**TO:** Members of the City Council

**FROM:** Adam Melita, Deputy City Attorney

**SUBJECT:** Certificate of Appropriateness at 534 Pembroke Avenue

Re: 534 Pembroke Avenue—Ghent Historic District—#15-60C

534 Pembroke Avenue

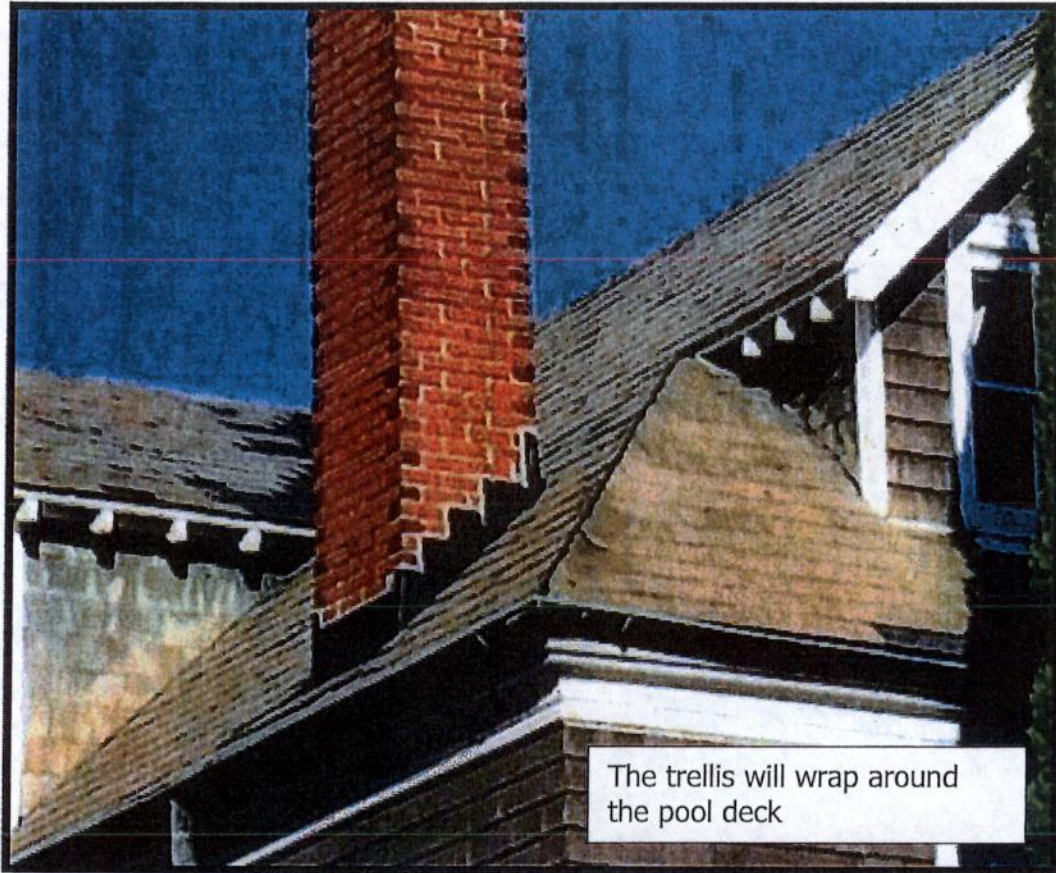
**V. Recommendation:** Staff recommends denial for a Certificate of Appropriateness for the slate roof replacement with composite slate, because it does not meet the *City of Norfolk Historic District Design Guidelines for Roofs*: (3) Replacement of original roofing materials with different roofing materials is strongly discouraged. The replacement should include detailed documentation as to condition and attempts to maintain the existing roof materials. If approved, it should replicate the original materials in color, shape size, and pattern.

Left is proposed composite slate/Middle & Right are existing slate tiles

The Board suggested that Mr. Ottinger find out if the composite material can be cut to match the 10 inch width of the existing slate. Ms. Pollard noted that under the Secretary of the Interior standards, the Virginia Department of Historic Resources will entertain using synthetic slate in situations where the slate is legitimately beyond repair and will match the profile, color and size of the existing slate. She added that Mr. Ottinger had provided appropriate documentation showing that the existing slate is beyond repair. She noted that should the 10 inch width be unavailable, the Board will have to work outside of the Guidelines which means they need to narrow the precedent for future applications.

Ms. Andrews made a motion to approve the composite material as presented provided that it is available in a dimension matching the existing slate (Guideline 2.2 No. 4). Mr. Klemt seconded the motion. The Board voted aye.

534 Pembroke Avenue-prior to roof changes

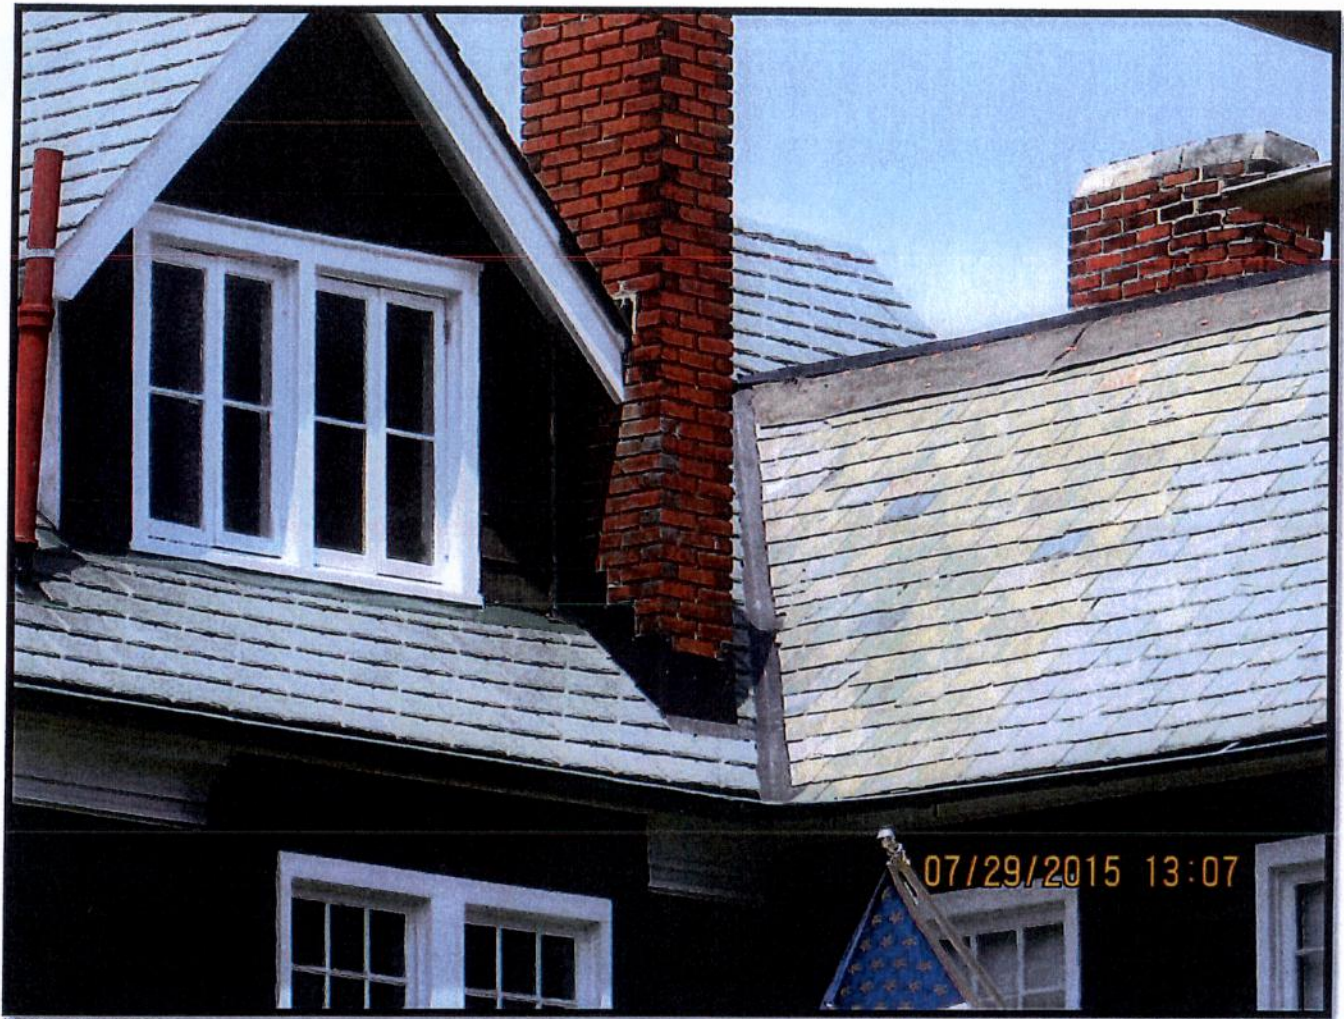
- V. **Recommendation:** Staff recommends denial for a Certificate of Appropriateness for the slate roof replacement with composite slate, because it does not meet the *City of Norfolk Historic District Design Guidelines for Roofs*: (3) Replacement of original roofing materials with different roofing materials is strongly discouraged. The replacement should include detailed documentation as to condition and attempts to maintain the existing roof materials. If approved, it should replicate the original materials in color, shape size, and pattern.

Most of the roof has been replaced with the DaVinci composite slate-note the difference in the installation of the composite material in the areas of the ridges. The valley of the original roof has oxidized to a brown patina and the installer used a green flashings

Left of the valley has been replaced to the right it has not

534 Pembroke Avenue-prior to roof changes

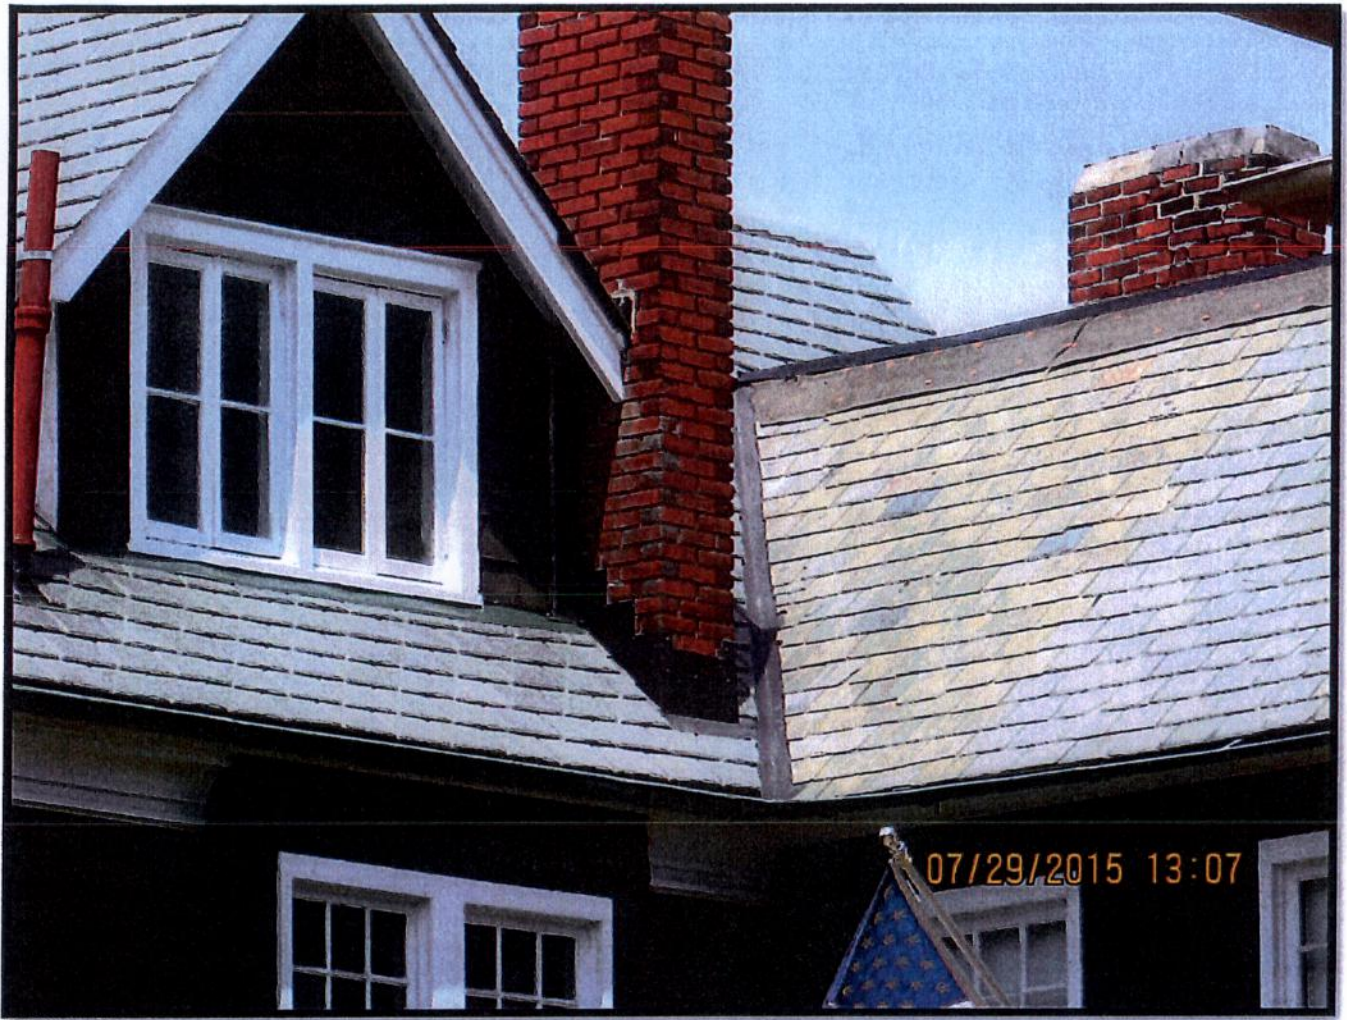
- V. Recommendation:** Staff recommends denial for a Certificate of Appropriateness for the slate roof replacement with composite slate, because it does not meet the *City of Norfolk Historic District Design Guidelines for Roofs*: (3) Replacement of original roofing materials with different roofing materials is strongly discouraged. The replacement should include detailed documentation as to condition and attempts to maintain the existing roof materials. If approved, it should replicate the original materials in color, shape size, and pattern.

Most of the roof has been replaced with the DaVinci composite slate-note the difference in the installation of the composite material in the areas of the ridges. The valley of the original roof has oxidized to a brown patina and the installer used a green flashings

Left of the valley has been replaced to the right it has not

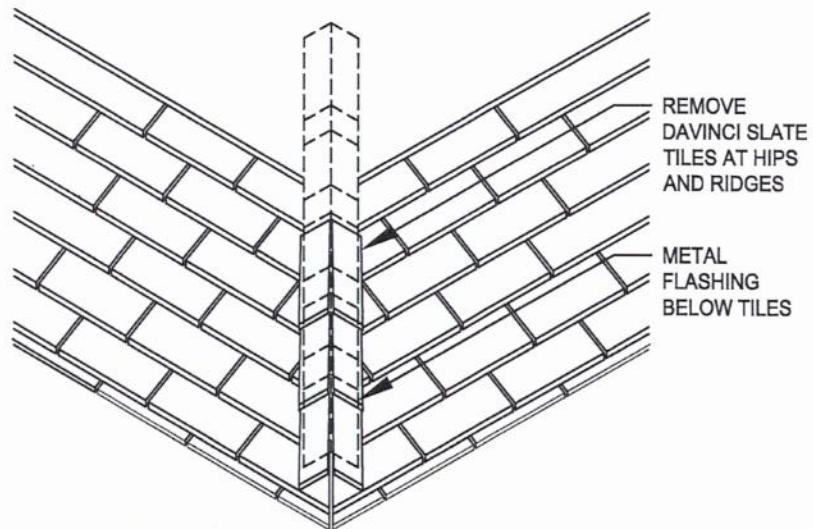
At today's meeting, Mr. Ottinger presented additional documentation and material samples. Ms. Pollard expressed concern that the drawings were still incomplete because they did not show any information about the valleys. Mr. Ottinger stated that information about the valleys had not been excluded intentionally and he would provide any documentation required. He added that he plans to install copper gutters and downspouts. He cited houses at 531 Warren Crescent (new construction) and 212 Colonial Avenue that have synthetic slate. He asked the Board to consider approving the Certificate of Appropriateness.

Mr. Rutledge made a motion to deny the application for failure to comply with Design Guideline 2-2, Roofs. Mr. Klemt seconded the motion. The Board voted aye.

HIP/ RIDGE CAP DETAIL  
 OTTINGER RESIDENCE  
 534 PEMBROKE AVE.  
 NORFOLK, VA 23507

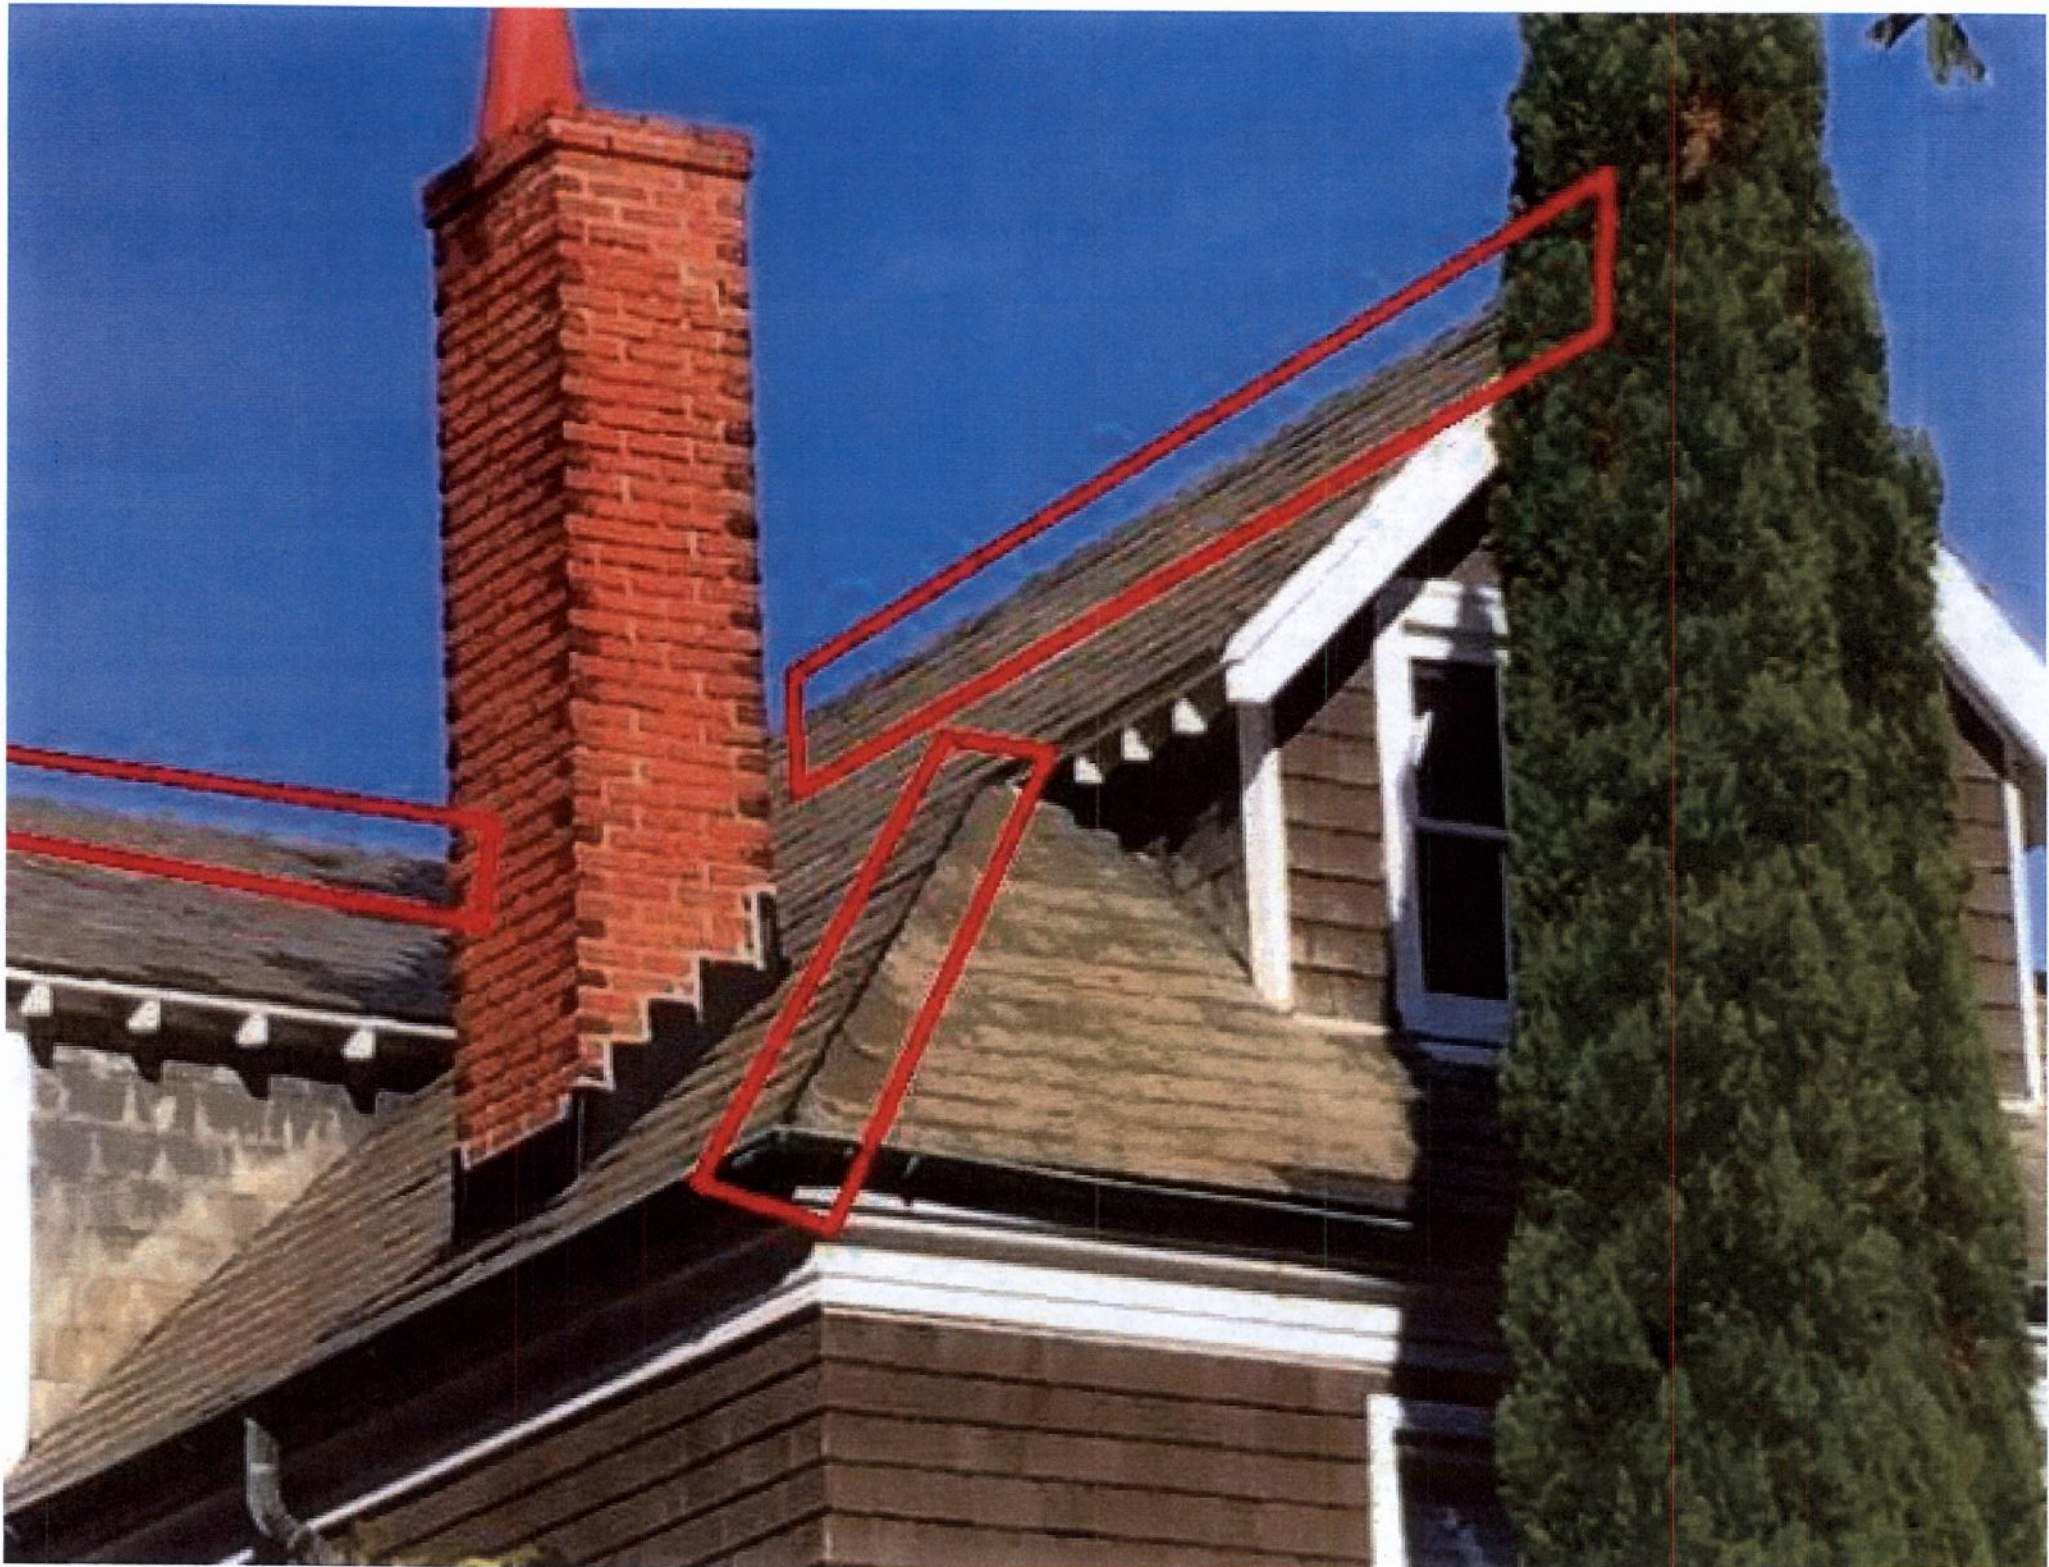
ridges, and valleys. The applicant has a response from the installer, where these existing areas can be reworked using copper flashing.
